MILITARY SPECIFICATION

MODULES, STANDARD ELECTRONIC

SWITCH, ANALOG, KEY CODE FAG

This amendments forms a part of Military Specification MIL-M-28787/113A(EC), dated 7 July 1981, and is approved for use by the Naval Electronic Systems Command, Department of the Navy, and is available for use by all Departments and Agencies of the Department of Defense.

FIGURE 5. Stress test circuit for table III.

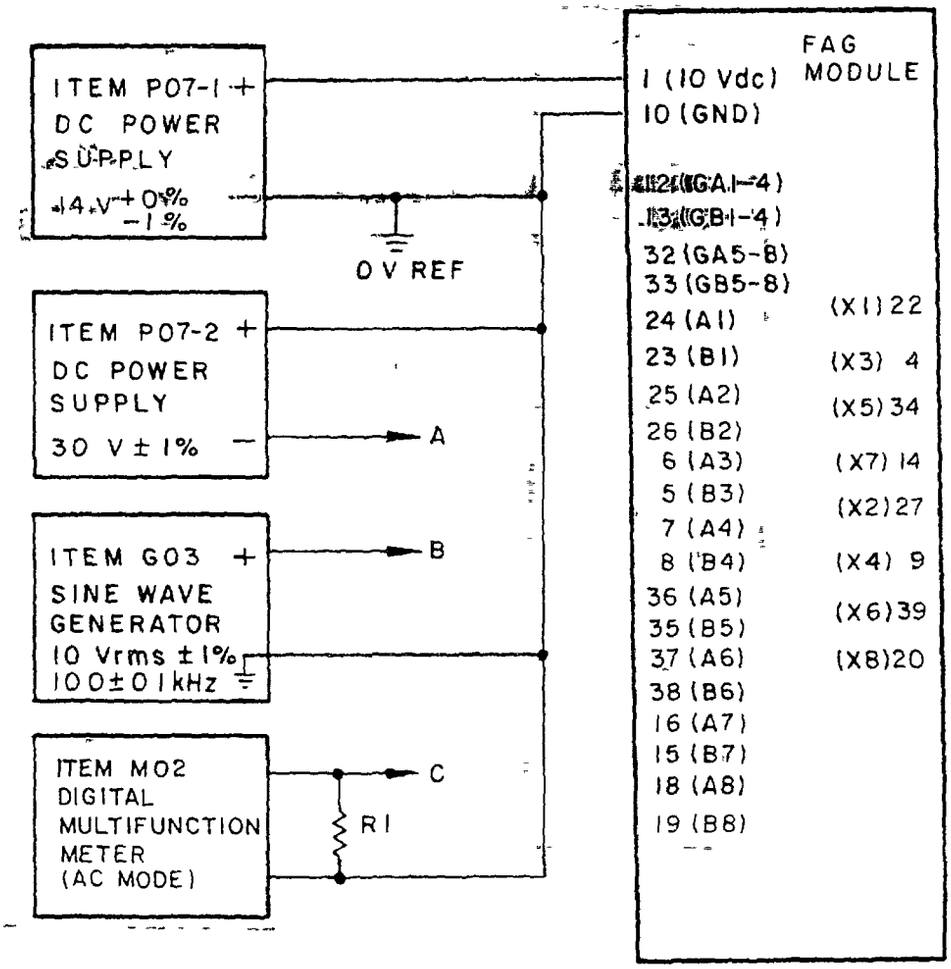
* FIGURE 5 Delete and substitute new figure 5 as printed on page 3 of this amendment.

NOTES
1. R1 = 100 kΩ ±1%, 1/8 W.
2. If test condition is successively repeated, the time interval between execution of each of these test conditions should be a minimum of 10 seconds in order to preclude detrimental effects due to module heating.

FIGURE 6 ON resistance check test circuit for test conditions C1-C16, table IV

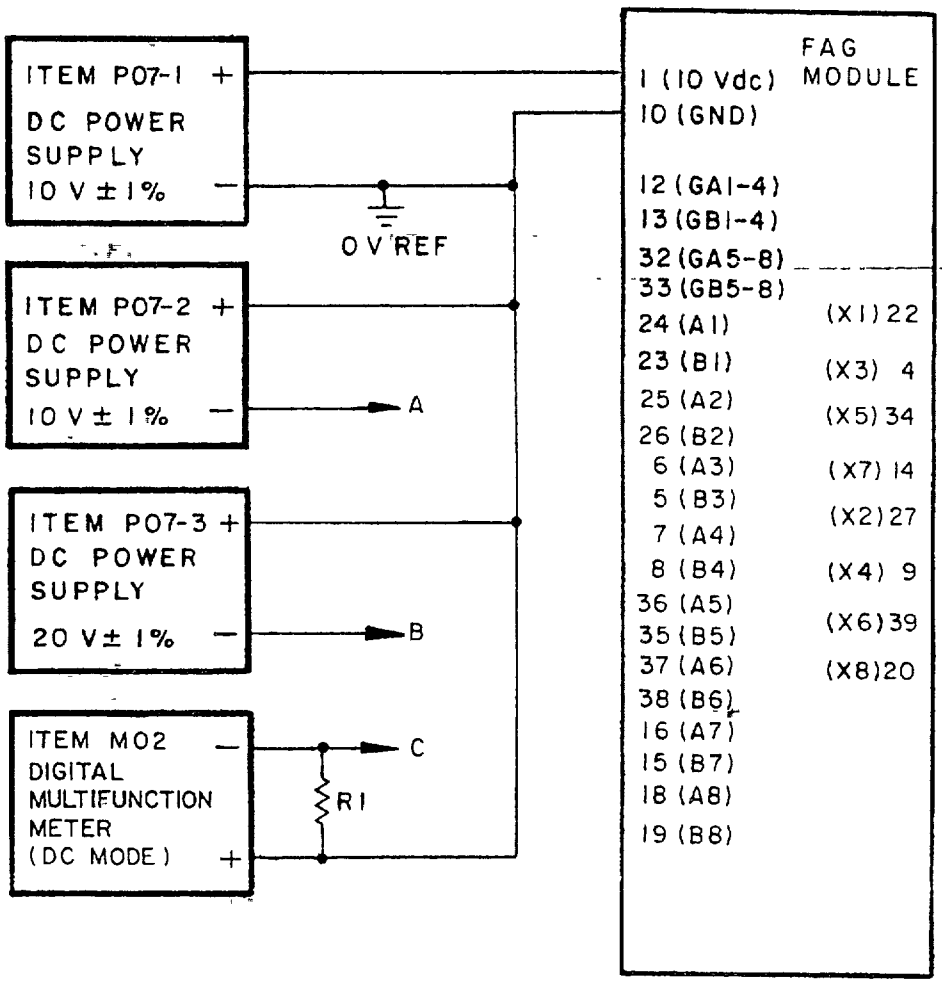
* FIGURE 6 Delete and substitute new figure 6 as printed on page 4 of this amendment.

NOTE R1 = 10 kΩ ±1%, 1/8 W.

FIGURE 7 ON resistance check test circuit for test conditions C17-C32, table IV.

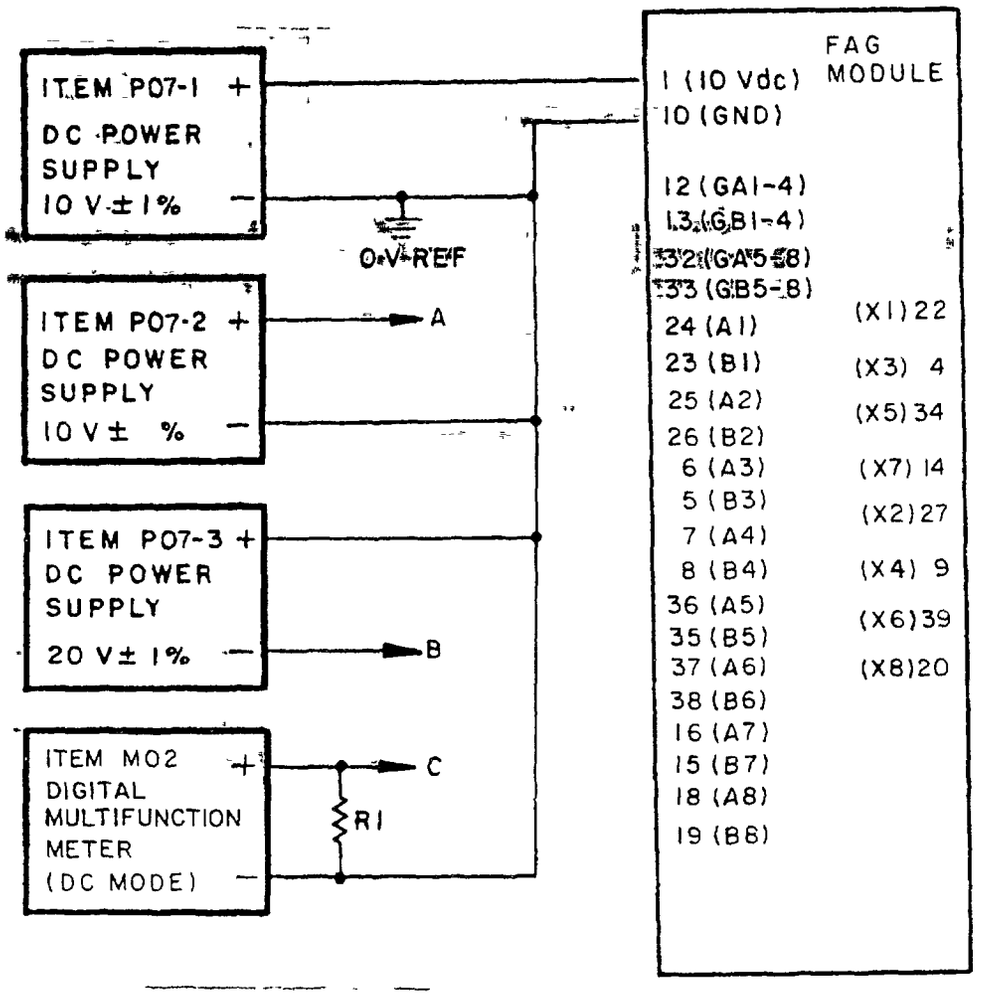
* FIGURE 7: Delete and substitute new figure 7 as printed on page 5 of this amendment.

NOTE: R1 = 10 kΩ ±1%, 1/8 W.

FIGURE 9. Analog input leakage current check test circuit for table VI

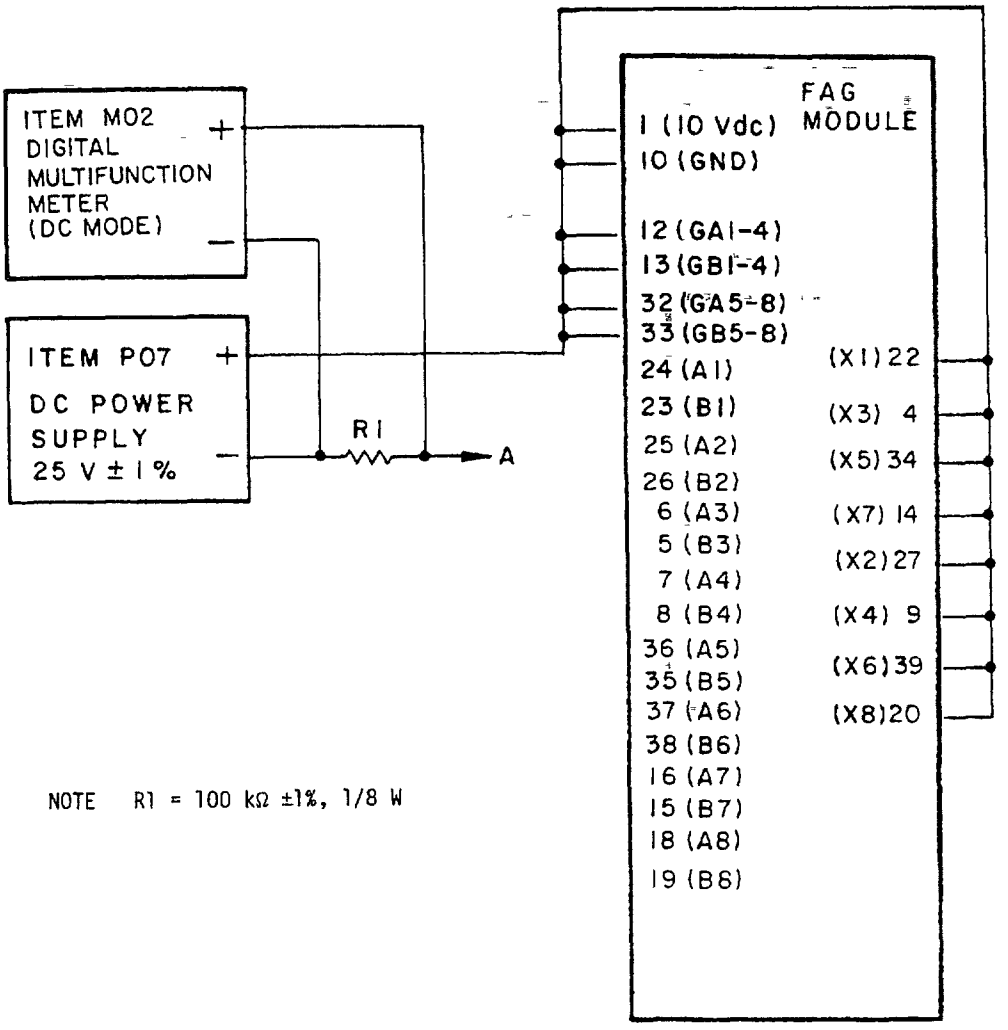
* FIGURE 9 Delete and substitute new figure 9 as printed on page 6 of this amendment.

NOTE R1 = 100 kΩ ±1%, 1/8 W

FIGURE 10. Gate input leakage current check test circuit for table VII

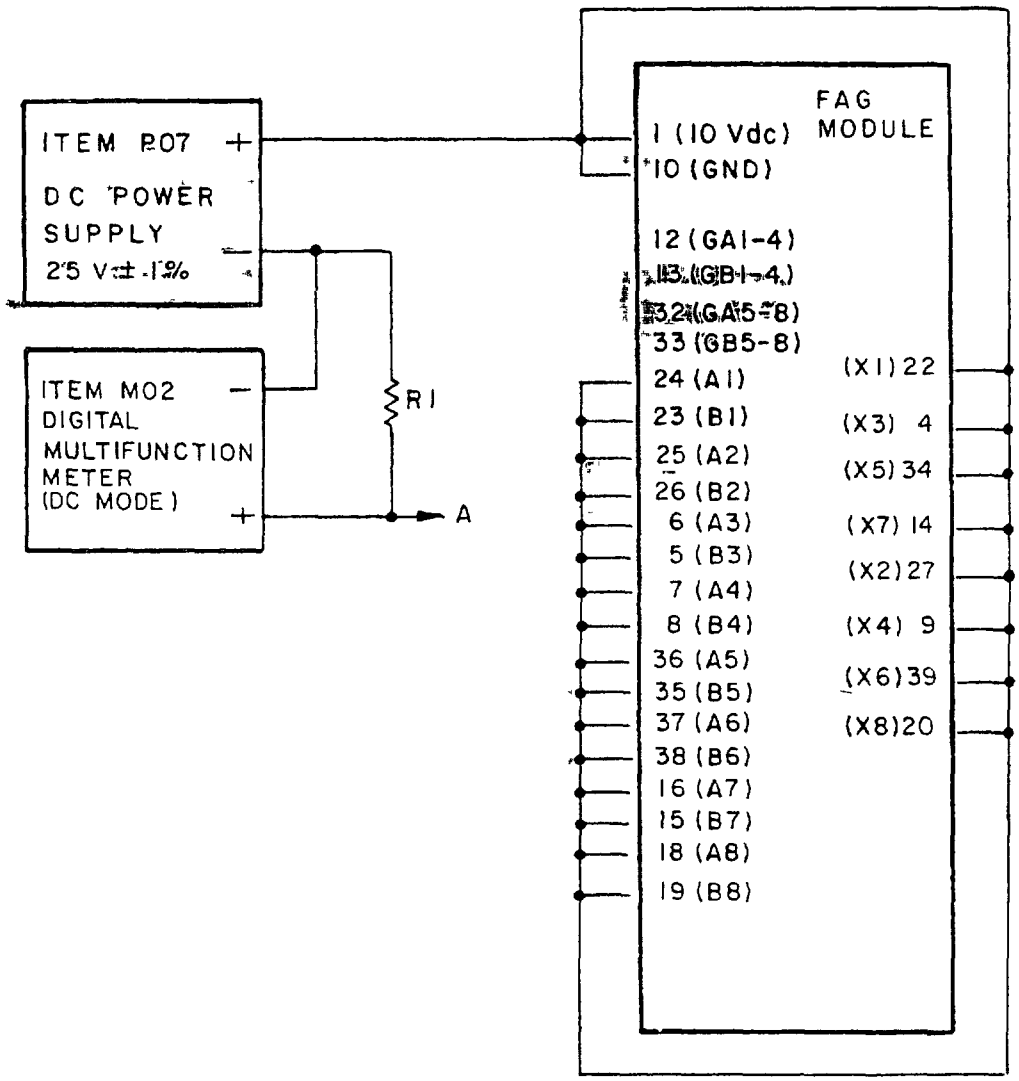
* FIGURE 10: Delete and substitute new figure 10 as printed on page 7 of this amendment.

NOTE: R1 = 100 kΩ ±1%, 1/8 W.

FIGURE 11 Output leakage current check test circuit for table VIII.

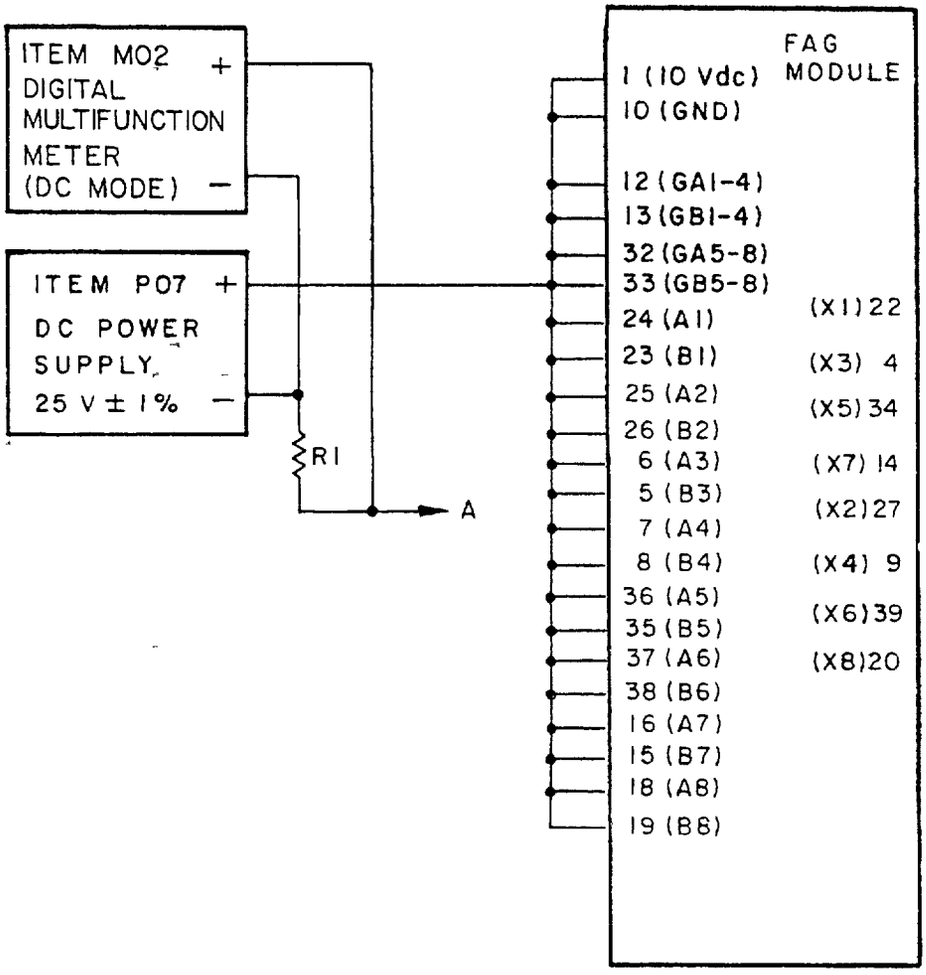
* FIGURE 11: Delete and substitute new figure 11 as printed on page 8 of this amendment.

NOTE R1 = 100 kΩ ±1%, 1/8 W.
